**APPLICATION FOR PERMISSION
UNDER SECTION 16 OF
THE TOWN PLANNING ORDINANCE
(CAP. 131)**

For Official Use Only 請勿填寫此欄	Application No. 申請編號	A/71-KTN/1107
	Date Received 收到日期	- 9 APR 2025

Application No. 申請編號	(For Official Use Only) (請勿填寫此欄)		
Location/address 位置／地址	Lots 1058 RP, 1059 RP, 1060 and 1061 in D.D. 107, Fung Kat Heung, Kam Tin, Yuen Long, New Territories		
Site area 地盤面積	912	sq. m 平方米	<input checked="" type="checkbox"/> About 約
	(includes Government land of 包括政府土地	N/A	sq. m 平方米 <input type="checkbox"/> About 約)
Plan 圖則	Approved Kam Tin North OZP No.: S/YL-KTN/11		
Zoning 地帶	"Agriculture" Zone		
Applied use/ development 申請用途／發展	Proposed Temporary Place of Recreation, Sports or Culture (Hobby Farm) with Ancillary Facilities and Associated Filling of Land for a Period of 5 Years

(S.16 Planning Application No. A/YL-KTN/1107)

KTN806-D01

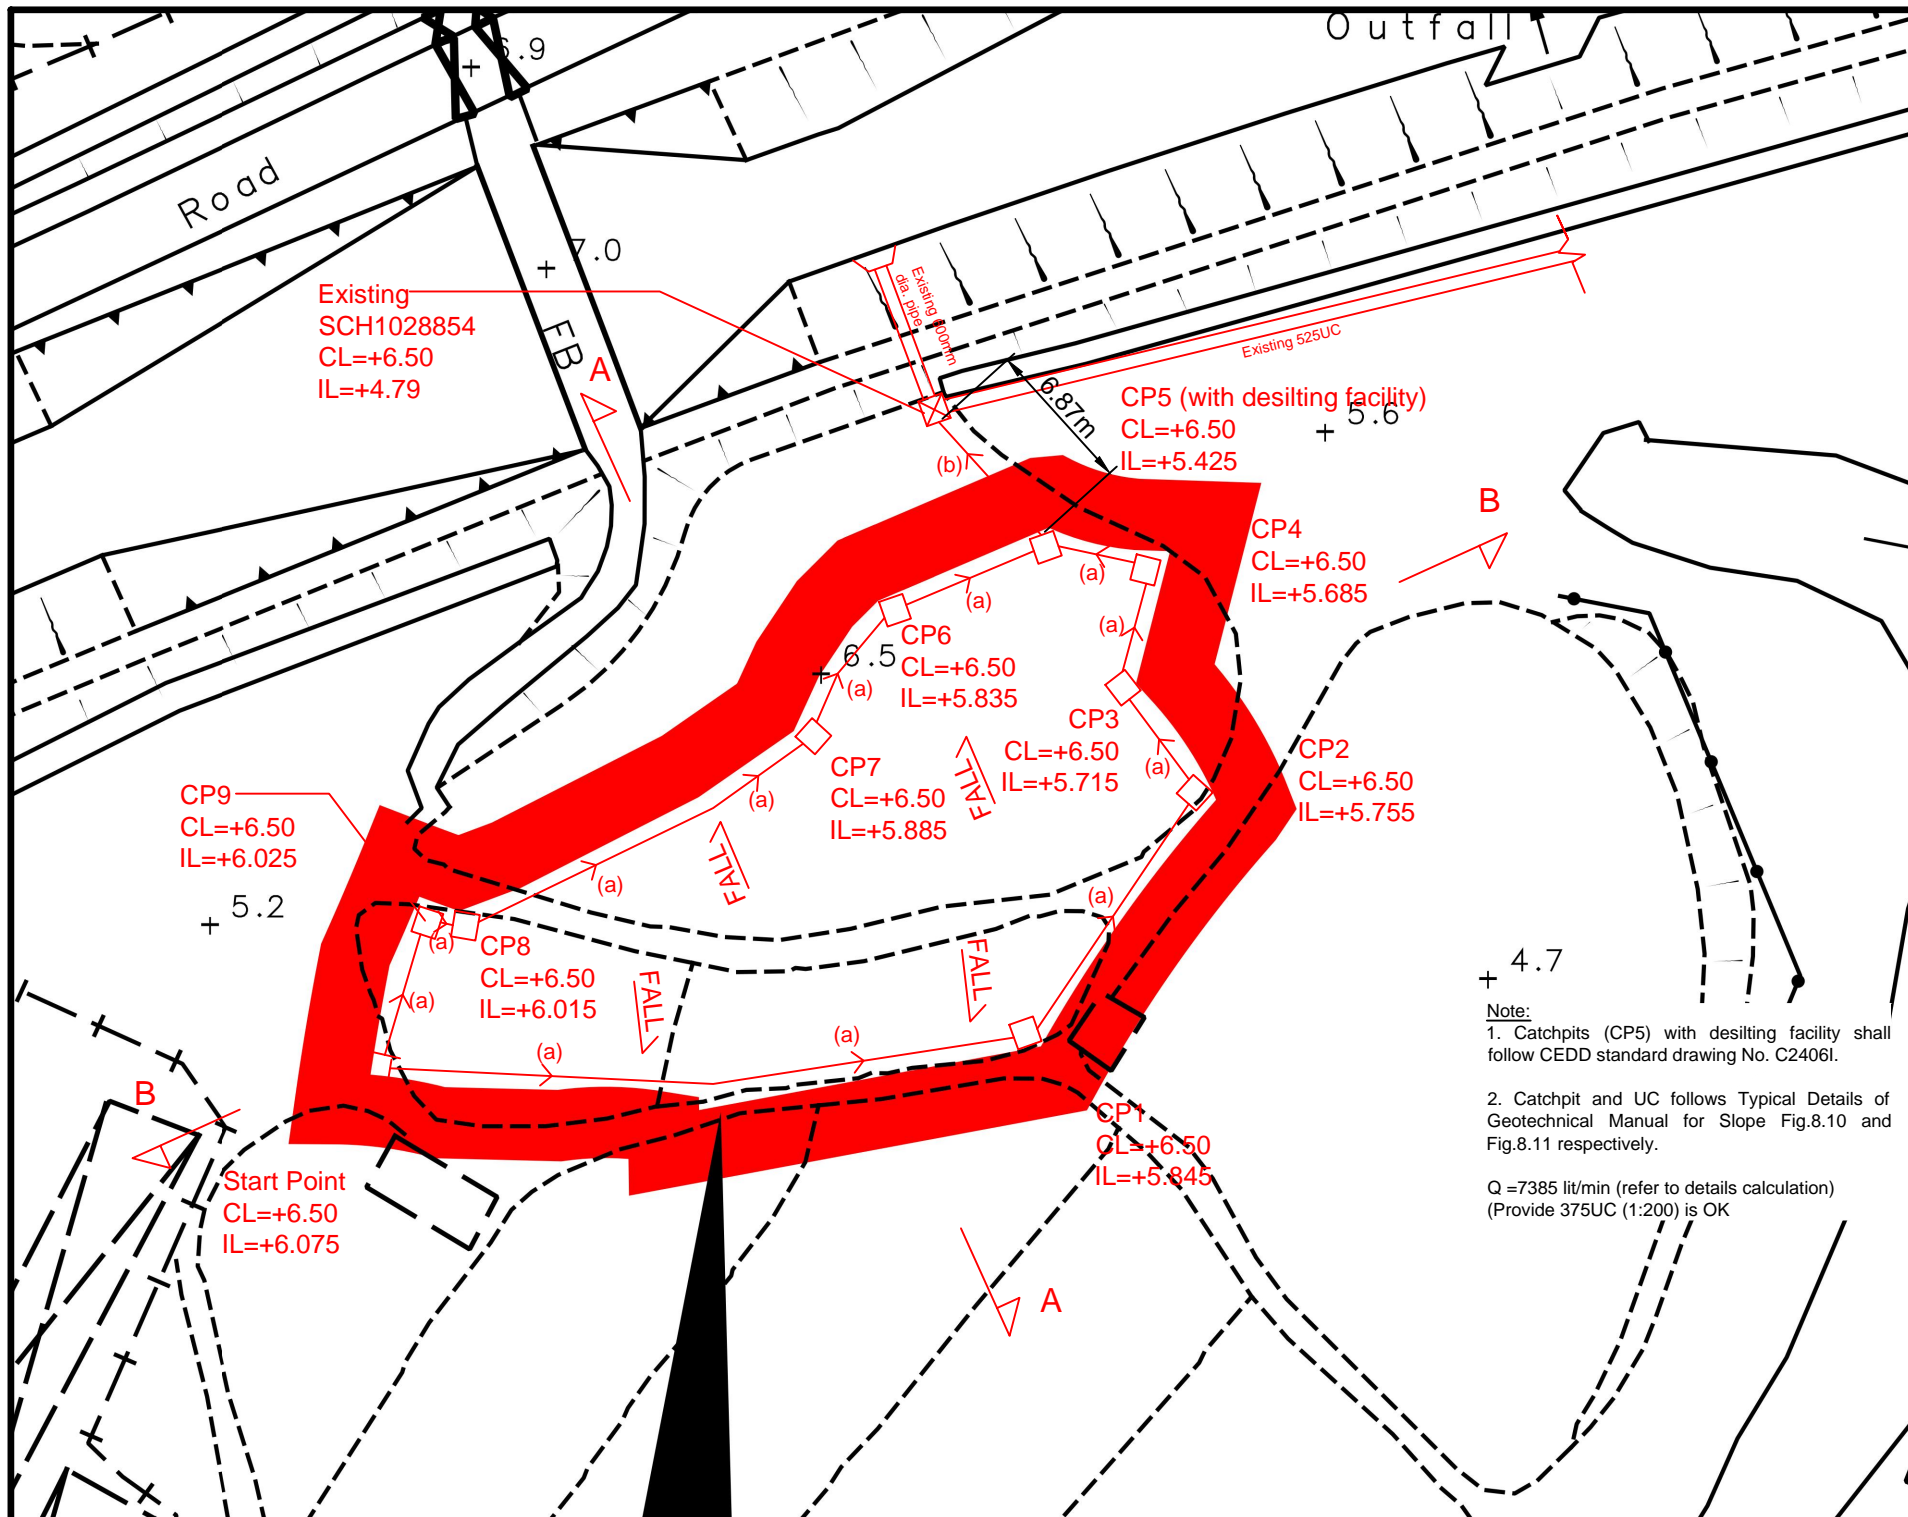
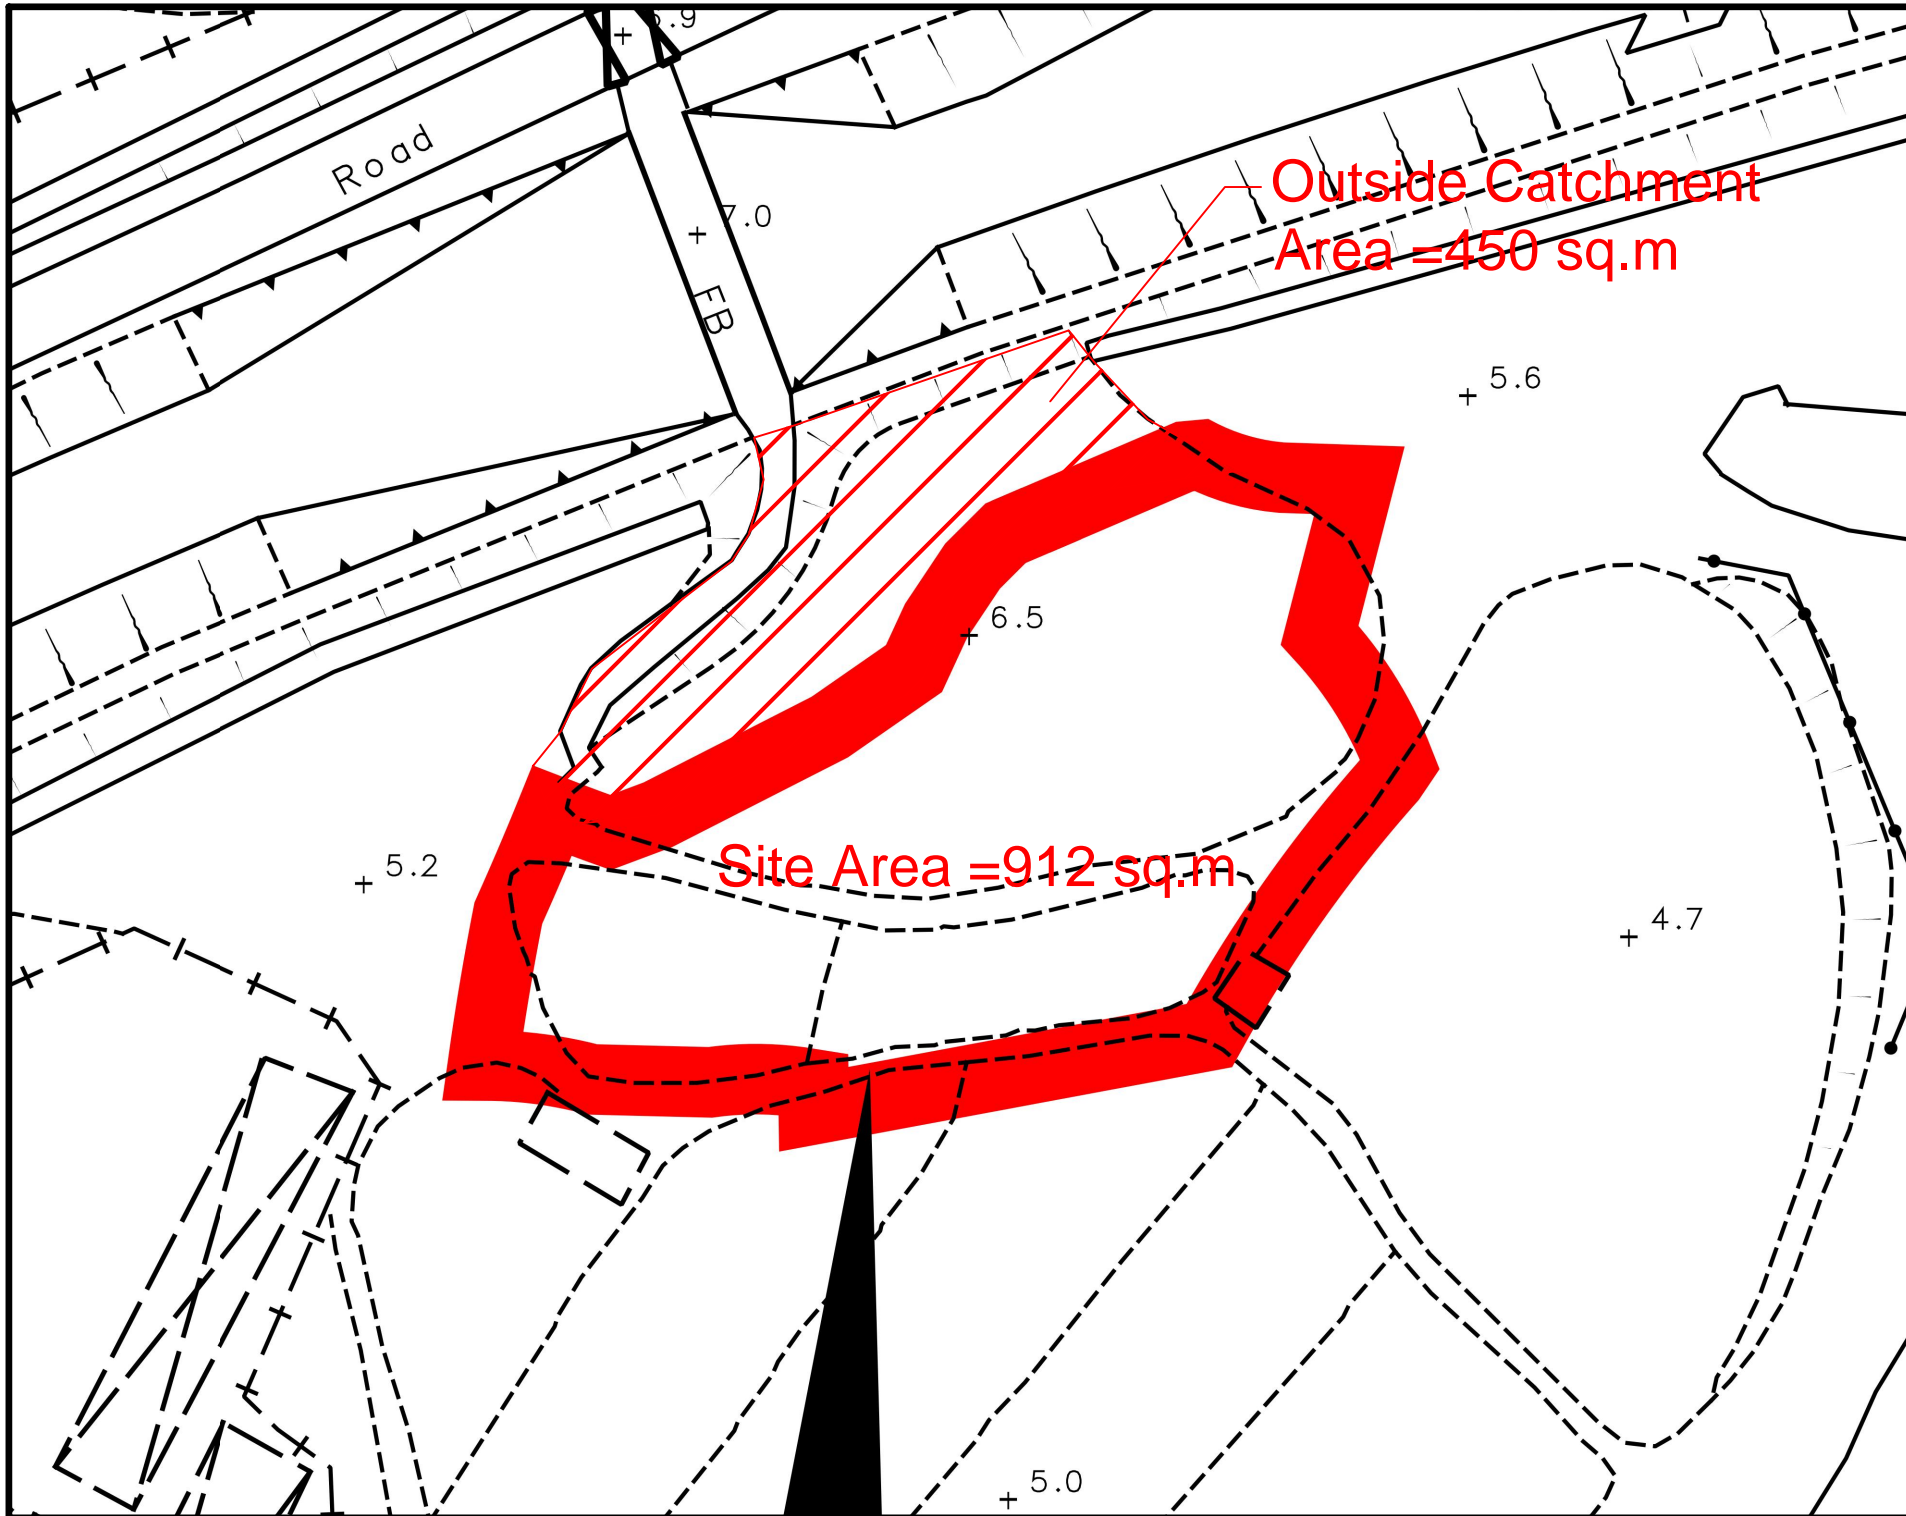
Comments of the CE/MN, DSD (Contact Person Mr. Terrence TANG; Tel:)		
(i)	SDM corrigendum nos. 1/2022 and 1/2024 should be considered in the assessment. Please consider to upgrade the drain size.	Noted. SDM corrigendum nos. 1/2022 and 1/2024 are followed, and the drain size is also upgraded accordingly (Appendix II).
(ii)	According to the SDM, the impact of a 50-year event should also be assessed.	Noted. A 50-year return period is also adopted in the proposal (Appendix II).
(iii)	Sediment reduction should be considered in the assessment.	Noted. Sedimentation is also considered in the proposal (Appendix II).
